FERMI NATIONAL ACCELERATOR LABORATORY
UNITED STATES DEPARTMENT OF ENERGY

HIGH DENSITY INTERCONNECT
9 CHIP BARREL HDI
BONDING DIAGRAM

SCALE	FILMED	DRAWING NUMBER	Sheet 2 of 2	REV.
		3823.112-MB-330190		F

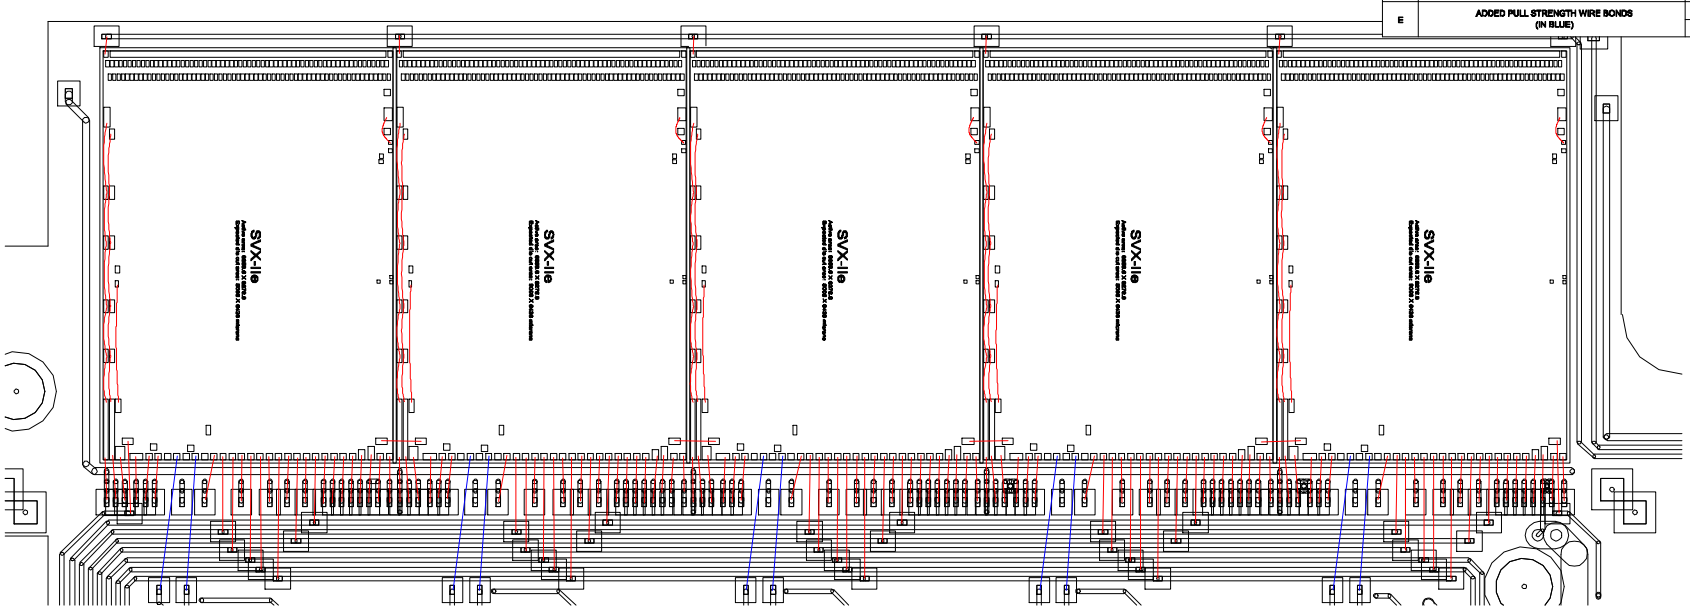
REV.	DESCRIPTION	DRAWN / APPD.	DATE
C	INDICATE POSITION OF 4 CIRCUIT CORRECTION WIRE BONDS (IN GREEN)	MATULIK	02/04/99
D	CORRECTED TO REPRESENT HDI 3954	MATULIK	03/11/99
E	ADDED PULL STRENGTH WIRE BONDS (IN BLUE)	MATULIK	01/11/00

REV.	DESCRIPTION	DRAWN / APPD.	DATE
F	REMOVED ONE PULL STRENGTH WIRE BOND DUE TO UNPLATED HDI PAD.	MATULIK	03/15/00
